**TSG-RAN Meeting #17**  
**Biarritz, France, 3 - 6 September 2002**

**RP-020547**

**Title:** Agreed CRs (Release '99 and Rel-4/Rel-5 category A) to TS 25.331  
**Source:** TSG-RAN WG2  
**Agenda item:** 7.2.3

**Figure 14.4.2.1-1: Event triggered report when Transport Channel Traffic Volume becomes larger than a certain threshold**

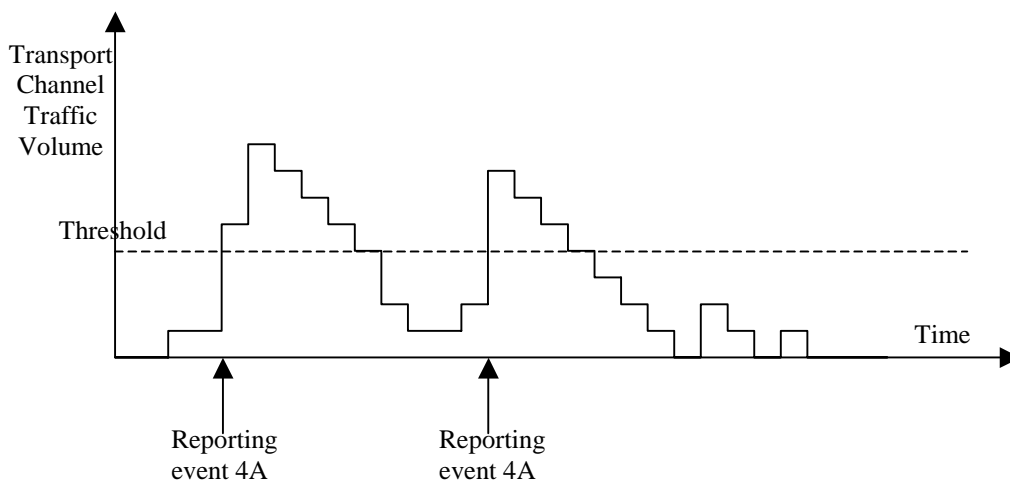
**Reason for change:** # The semantics description for the Time-to-trigger is erroneous. It is not clear how the Tx Interruption functionality works when multiple events are triggered before the Tx Interruption time elapses. This is allthemore complicated that different events could be configured with different "Tx Interruption after trigger" values.  
~~A clarification of the fact that the two reporting modes could be configured at the same time was carried over from the MAC specification, since it seemed to be more relevant here.~~

**Summary of change:** # Corrected the semantics description of the Time-to-trigger  
~~Introduced a Note to clarify that both reporting modes could be configured at the same time.~~  
 Clarified the Tx interruption functionality.

If the monitored Transport Channel Traffic Volume (TCTV) [15] becomes larger than an absolute threshold, i.e. if  $TCTV > \text{Reporting threshold}$ , this event could trigger a report. The event could be triggered again only if  $TCTV < \text{Reporting threshold}$  and later  $TCTV > \text{Reporting threshold}$  is verified again.

**Figure 14.4.2.1-1: Event triggered report when Transport Channel Traffic Volume becomes larger than a certain threshold**

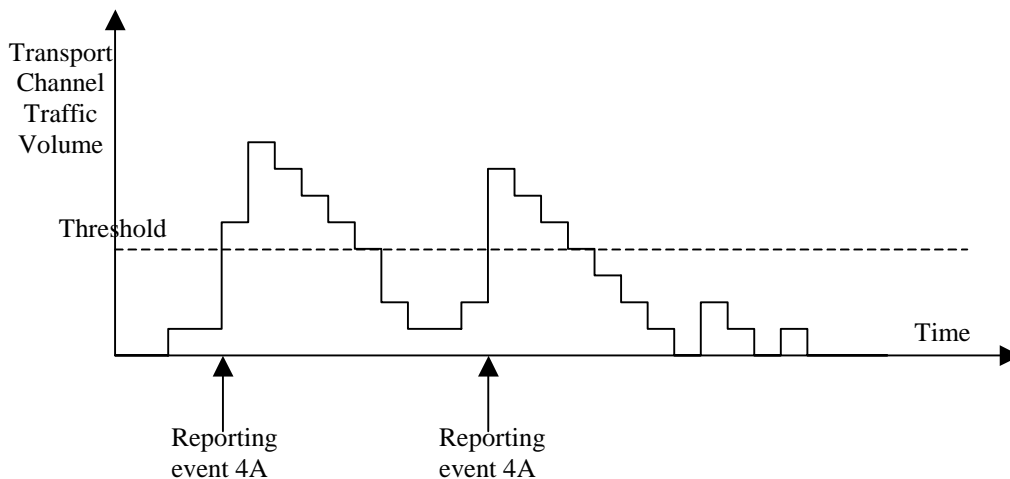
<b>Reason for change:</b>	# The semantics description for the Time-to-trigger is erroneous. It is not clear how the Tx Interruption functionality works when multiple events are triggered before the Tx Interruption time elapses. This is allthemore complicated that different events could be configured with different "Tx Interruption after trigger" values. <del>A clarification of the fact that the two reporting modes could be configured at the same time was carried over from the MAC specification, since it seemed to be more relevant here.</del>
<b>Summary of change:</b>	# Corrected the semantics description of the Time-to-trigger Introduced a Note to clarify that both reporting modes could be configured at the same time. Clarified the Tx interruption functionality.
<b>Consequences if not approved:</b>	# Ambiguity in the specification.

If the monitored Transport Channel Traffic Volume (TCTV) [15] becomes larger than an absolute threshold, i.e. if  $TCTV > \text{Reporting threshold}$ , this event could trigger a report. The event could be triggered again only if  $TCTV < \text{Reporting threshold}$  and later  $TCTV > \text{Reporting threshold}$  is verified again.

**Figure 14.4.2.1-1: Event triggered report when Transport Channel Traffic Volume becomes larger than a certain threshold**

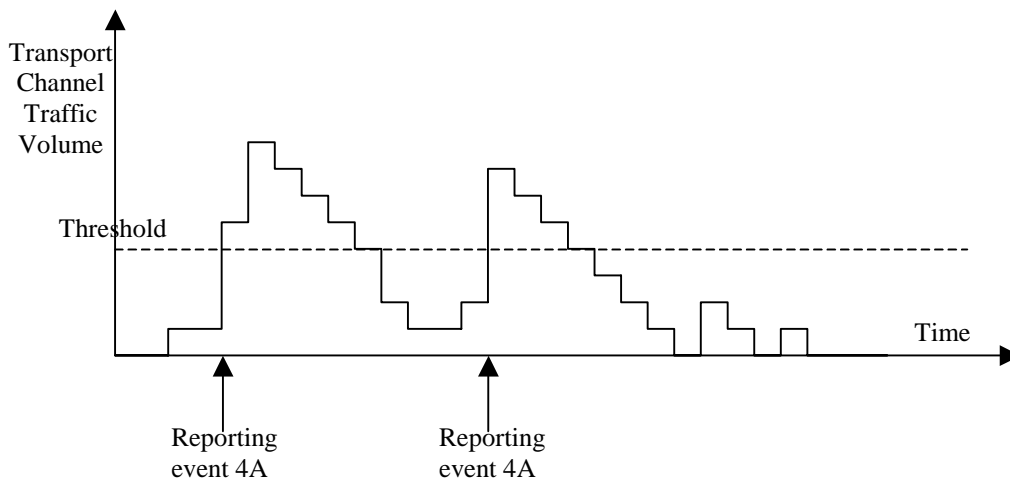
<b>Reason for change:</b>	# The semantics description for the Time-to-trigger is erroneous. It is not clear how the Tx Interruption functionality works when multiple events are triggered before the Tx Interruption time elapses. This is allthemore complicated that different events could be configured with different "Tx Interruption after trigger" values. <del>A clarification of the fact that the two reporting modes could be configured at the same time was carried over from the MAC specification, since it seemed to be more relevant here.</del>
<b>Summary of change:</b>	# Corrected the semantics description of the Time-to-trigger Introduced a Note to clarify that both reporting modes could be configured at the same time. Clarified the Tx interruption functionality.
<b>Consequences if not approved:</b>	# Ambiguity in the specification.

If the monitored Transport Channel Traffic Volume (TCTV) [15] becomes larger than an absolute threshold, i.e. if  $TCTV > \text{Reporting threshold}$ , this event could trigger a report. The event could be triggered again only if  $TCTV < \text{Reporting threshold}$  and later  $TCTV > \text{Reporting threshold}$  is verified again.
